Value Engineering Study

***EAST NICHOLASVILLE BYPASS
JESSAMINE COUNTY, KENTUCKY***

ITEM NUMBER 7-87.01

Study Date: July 19 - 23, 2010
Draft Report Date: July 30, 2010

VALUE ENGINEERING RECOMMENDATION # VE-2

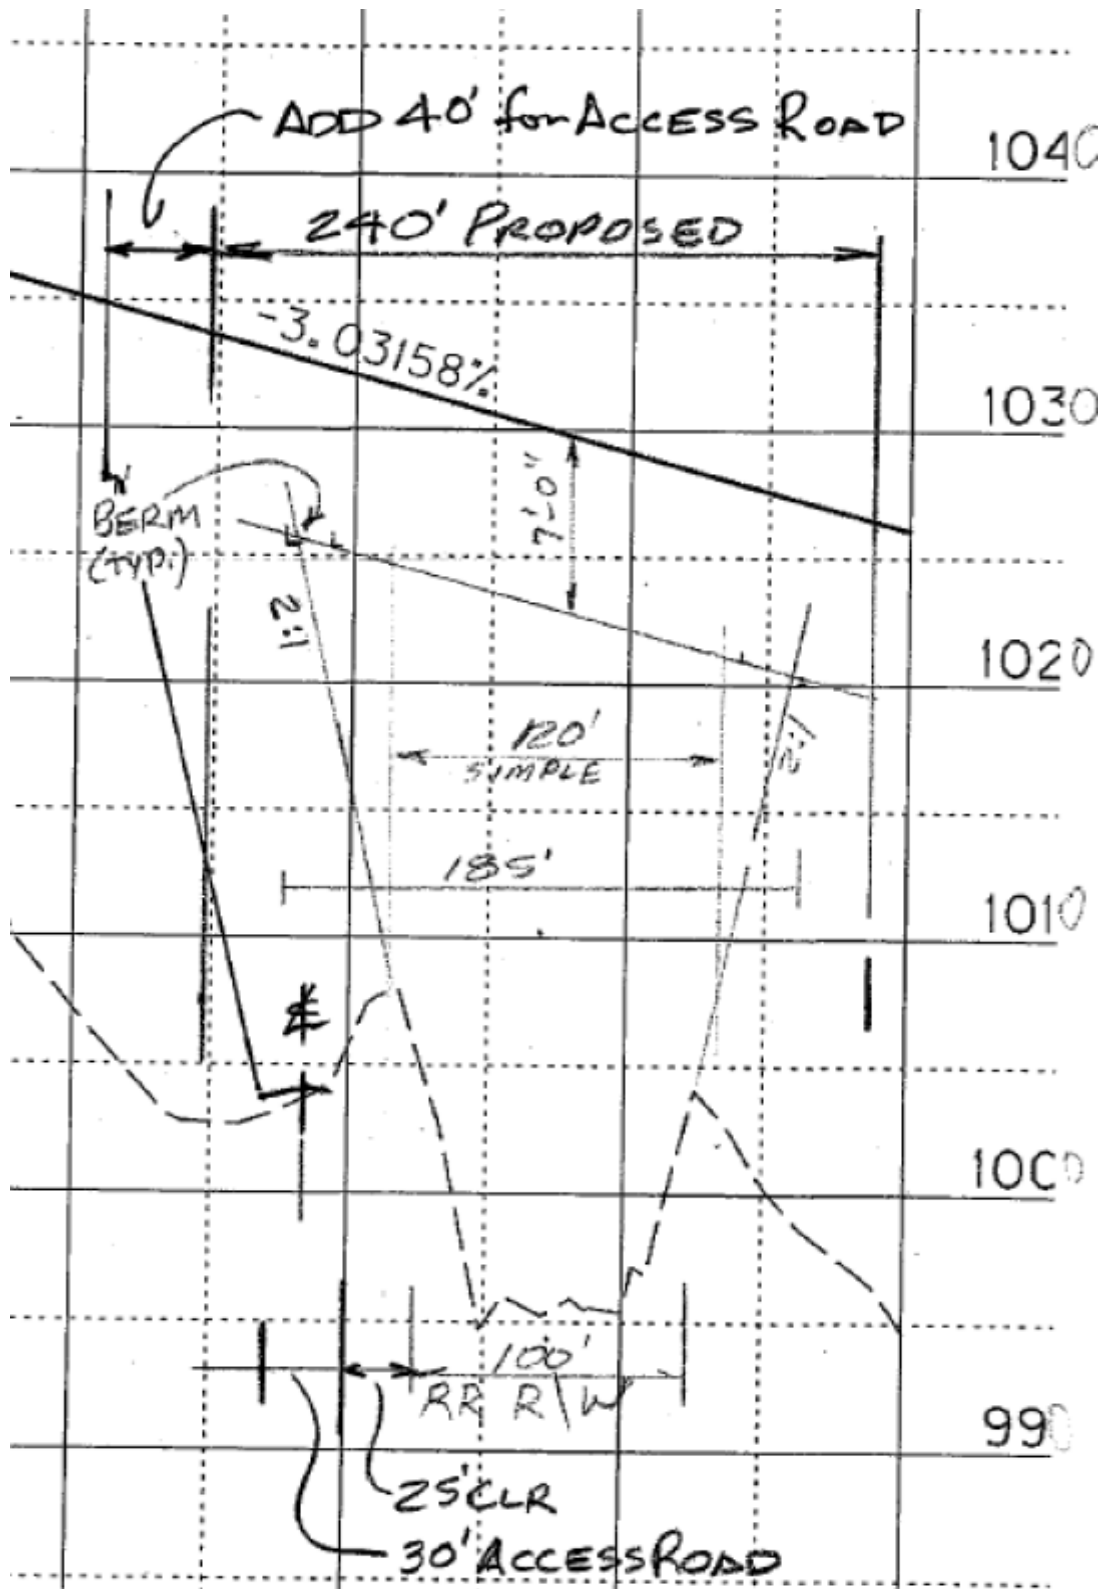
Utilize vertical wall abutment in lieu of a sloped earth embankment at the railroad abutments.

The original design specifies a curved twin bridges over the Railroad. Span Lengths are not yet determined. The bridge outlines are indicated on the plan with a length of 240 ft. The deck widths scale to 44 and 64 ft. This equates to a bridge cost of \$103/SF.

The VE team recommends evaluation of vertical wall abutments to save bridge deck area and beam lengths by reducing the bridge length.

VALUE ENGINEERING RECOMMENDATION # VE-3

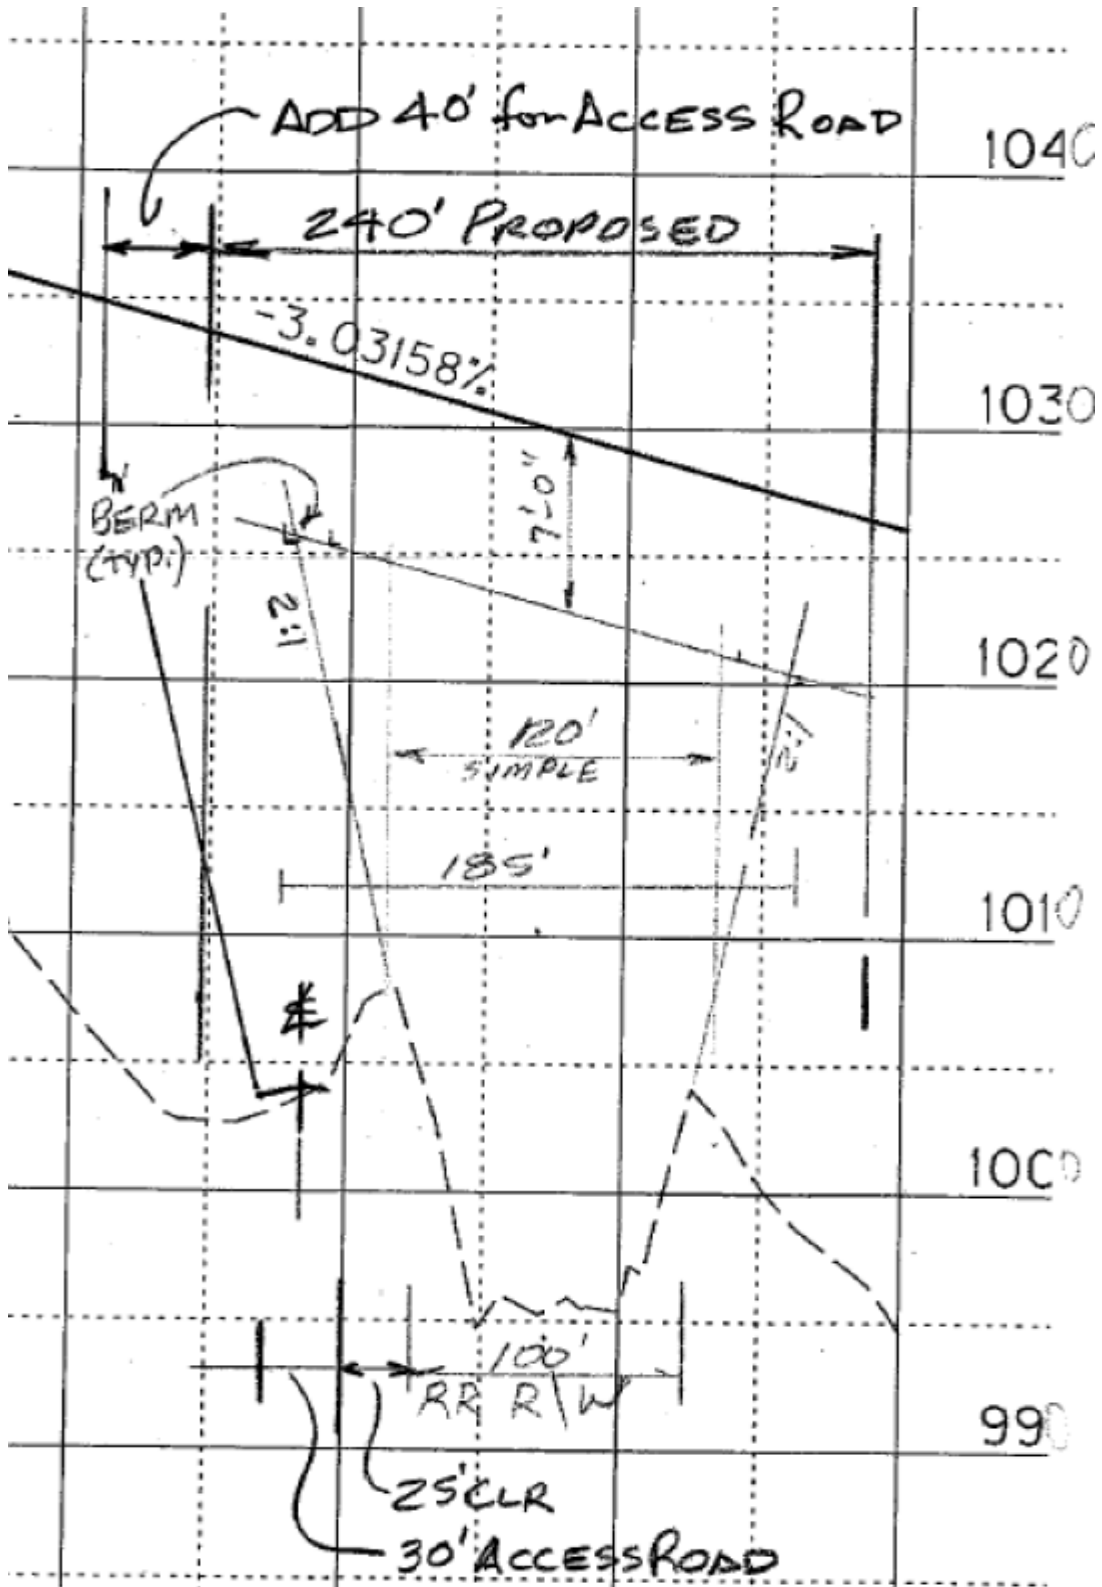
Utilize a longer bridge at the railroad to provide property to property access in lieu of a separate wagon box for access.

The original design indicates a 60 ft wide wagon box to provide access to either side of a divided property between US 27 and the railroad. Realistically, this will be approximately 30 ft wide and 180 ft in length. The cost for this item is not in the provided cost estimate.

The VE team recommends extending the railroad bridge for another span to allow access in lieu of constructing the wagon box. A 30 ft wide access road will provide much better access but after analysis, does represent an increase in cost.

VALUE ENGINEERING RECOMMENDATION # VE-7

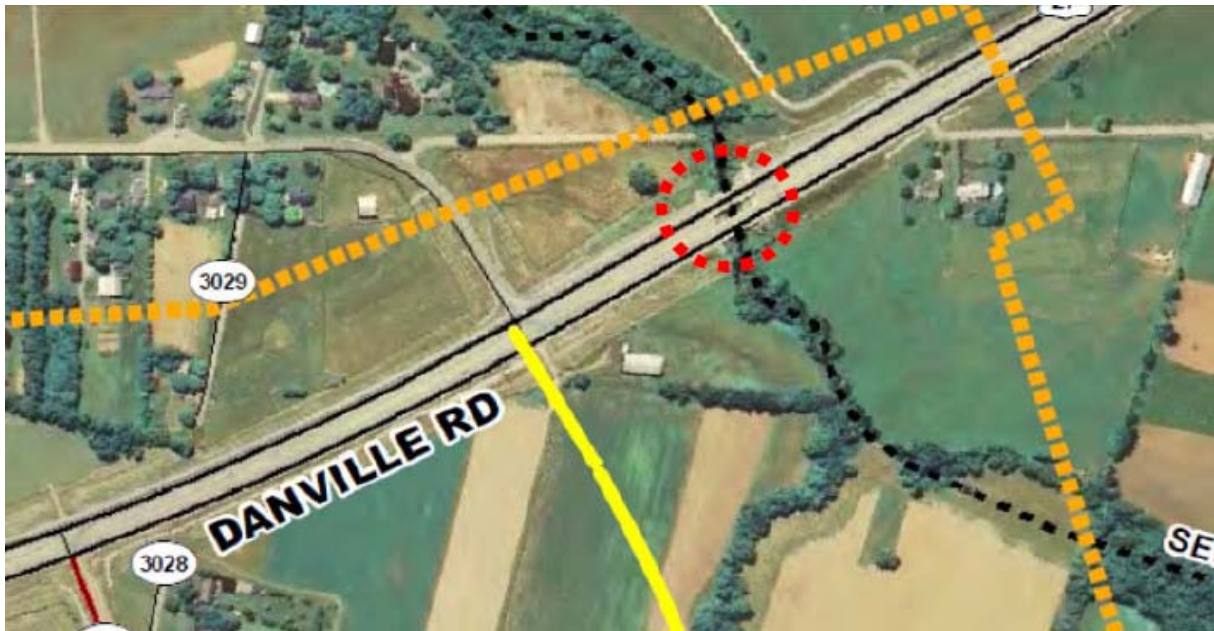
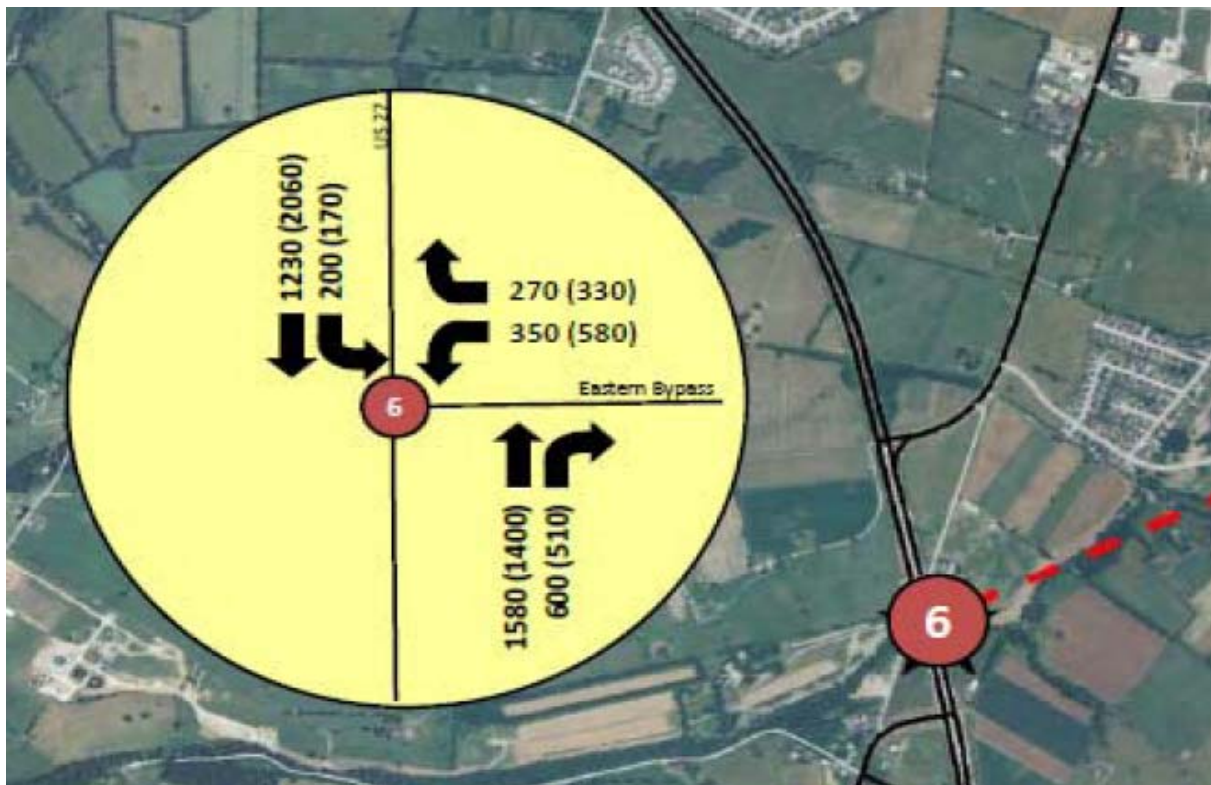
Utilize a single left in lieu of dual lefts from the existing bypass onto the new bypass at the southern terminus and eliminate any impact to the existing bridges.

The original design specifies a dual left turn lane from the existing US 27 Bypass south of Nicholasville to the proposed bypass. The required widening for the dual left turn lanes extends into the existing bridge on US 27, thus requiring it to be widened.

The VE team recommends eliminating the dual left turn lanes and shortening the left turn lane storage. This would eliminate the need to widen the existing US 27 bridge.

The draft traffic forecast shows 200 DHV turning left onto the proposed bypass. Based on capacity analysis, a minimum of 470 ft (storage + taper + deceleration) is needed for the left turn lane. The distance between the end of the existing bridge to the nose of median at the bypass is 505 ft. Therefore, a single left turn lane would operate effectively at this location and fit into the space available without modifying the bridge.

VALUE ENGINEERING RECOMMENDATION # VE-9

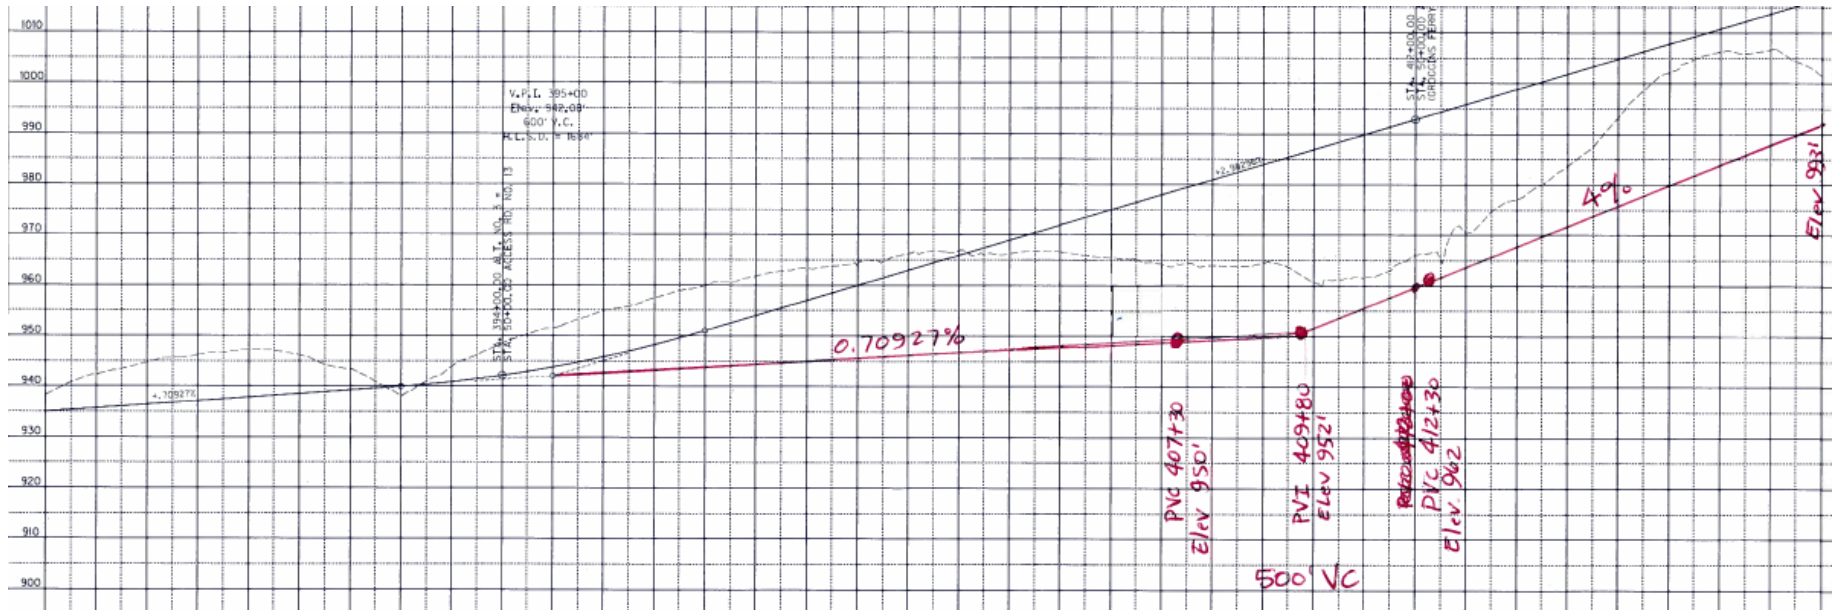
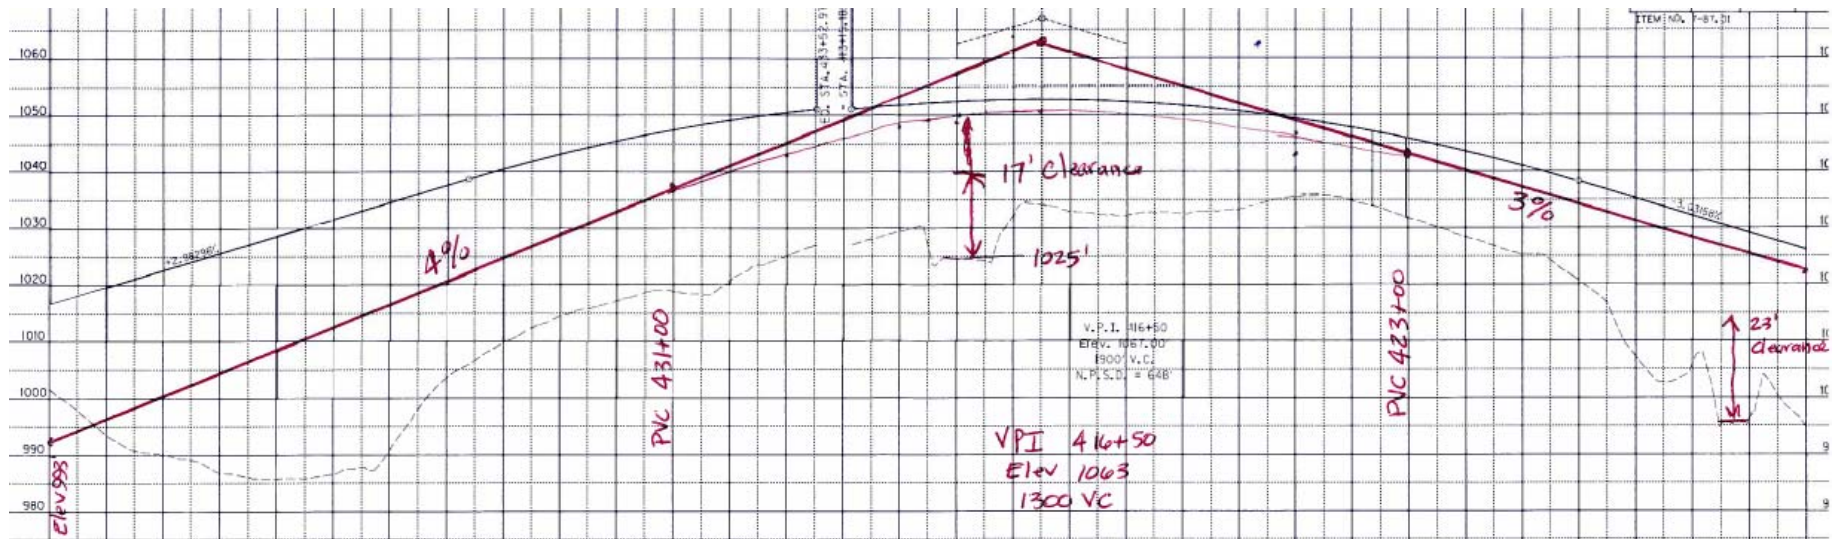
Adjust the profile grade by utilizing a 4% grade approaching US 27 from Station 395+00 to Station 416+50 (ahead) and lower the clearance over the railroad tracks to 23 ft and US 27 to 17 ft to reduce the required embankment.

The original design specifies the bypass approach grade to US 27 as 2.98296% from Station 395+00 to Station 416+50 (ahead). This section is in an embankment and requires a borrow site. Additionally, the proposed clearance of the bypass over US 27 appears to be 21 ft and the clearance over the railroad appears to be 27 ft.

The VE team recommends extending the 0.70927% grade from Station 395+00 to Station 409+80 and then utilizing a 4% approach grade in lieu of the 2.98296% to Station 416+50 (ahead). The VE team also recommends changing the overhead clearance over US 27 to 17 ft and the railroad clearance to 23 ft.

SKETCH OF ORIGINAL DESIGN

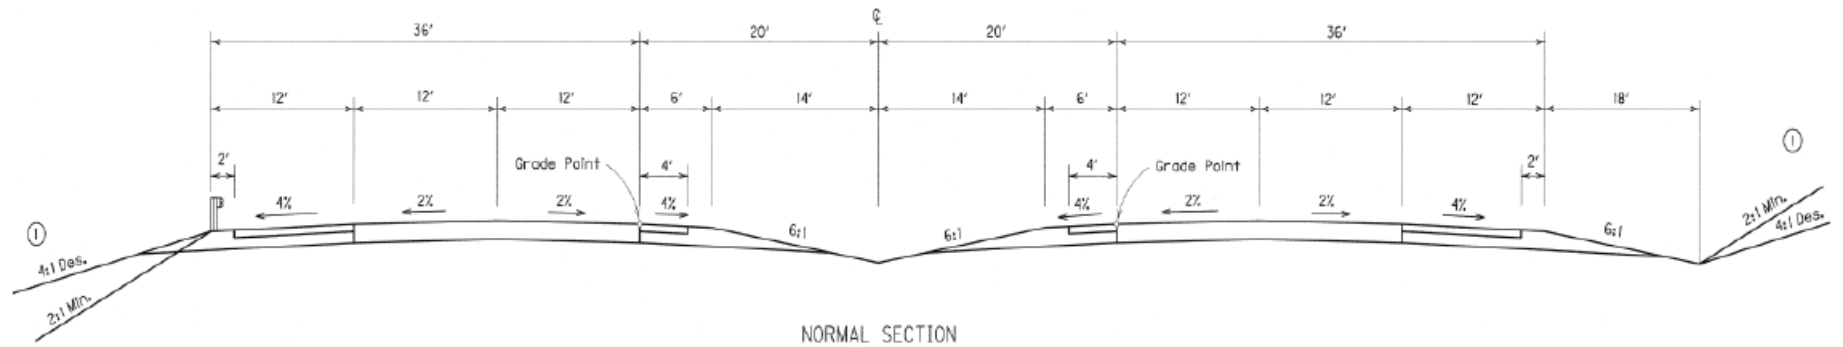
Utilize 11 ft lanes in lieu of 12 ft lanes throughout the new east bypass.

The original design specifies 12 ft lanes throughout the proposed bypass.

VALUE ENGINEERING RECOMMENDATION # VE-18a

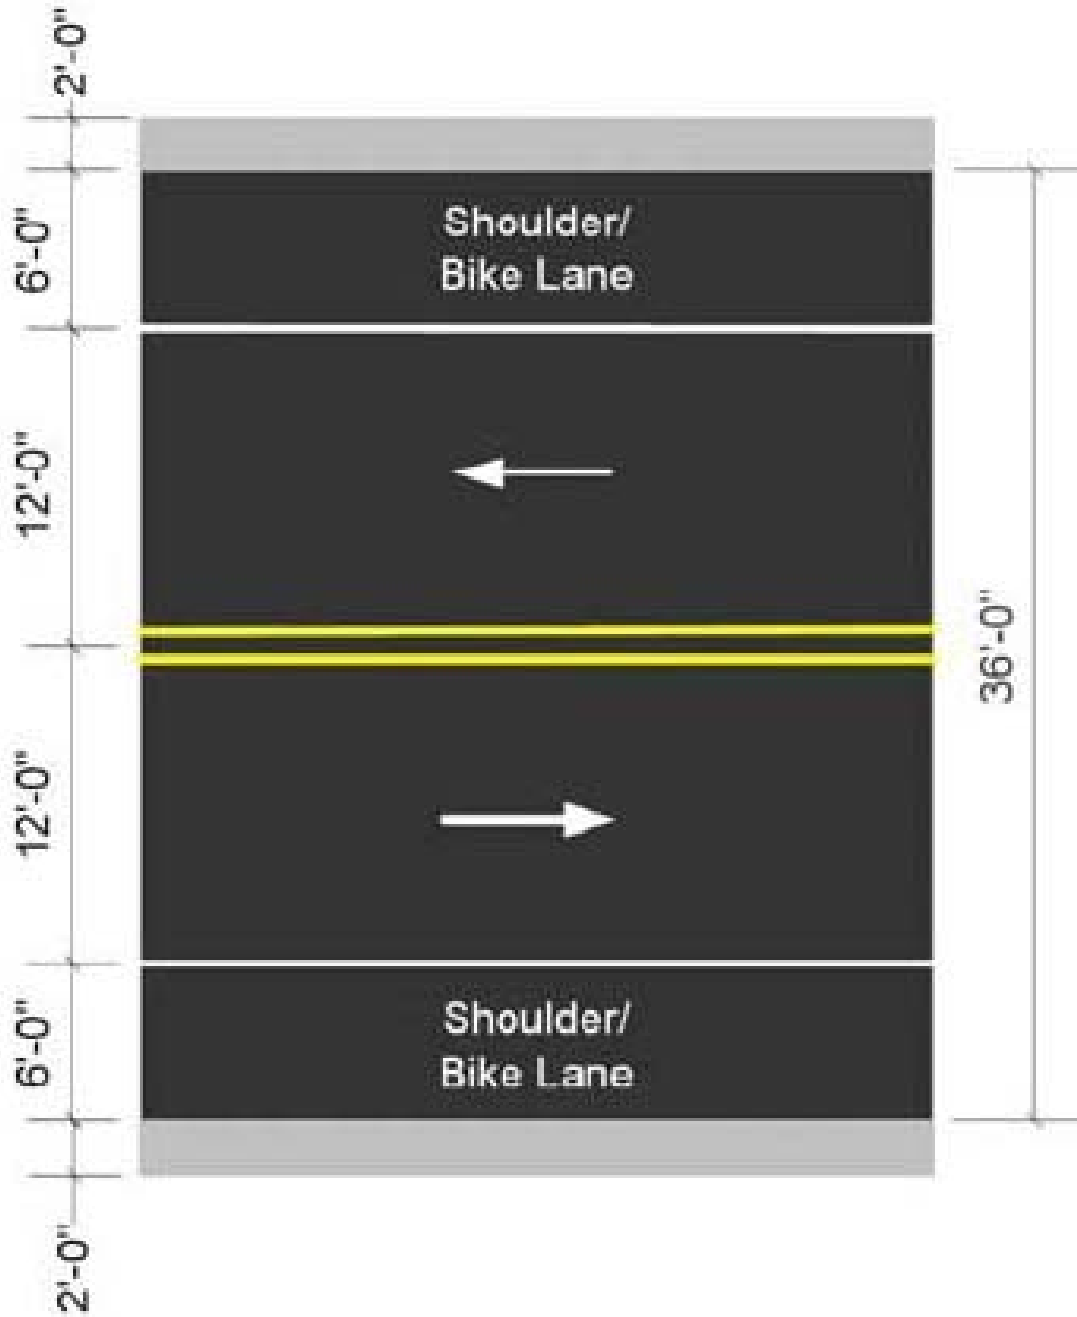
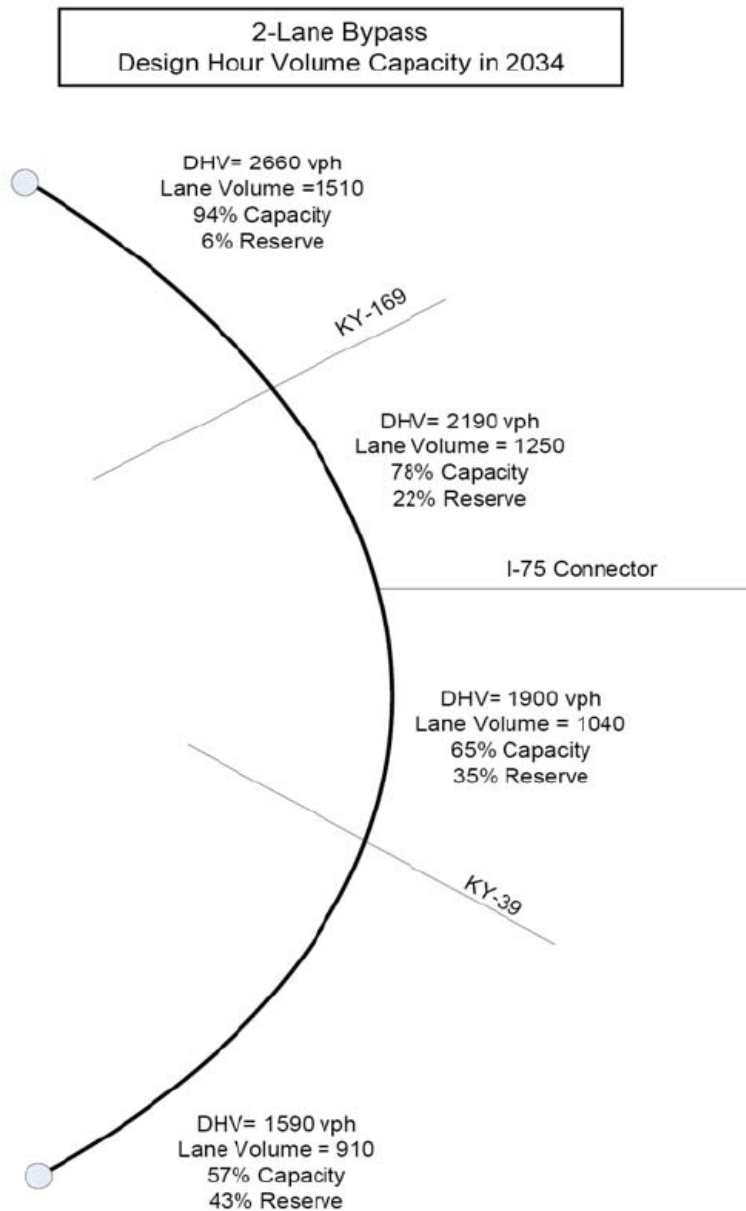
SUMMARY OF COST ANALYSIS			
	First Cost	O & M Costs (Present Worth)	Total LC Cost (Present Worth)
ORIGINAL DESIGN	\$18,224,000	\$0	\$18,224,000
RECOMMENDED DESIGN	\$3,824,000	\$0	\$3,824,000
ESTIMATED SAVINGS OR (COST)	\$14,400,000	\$0	\$14,400,000
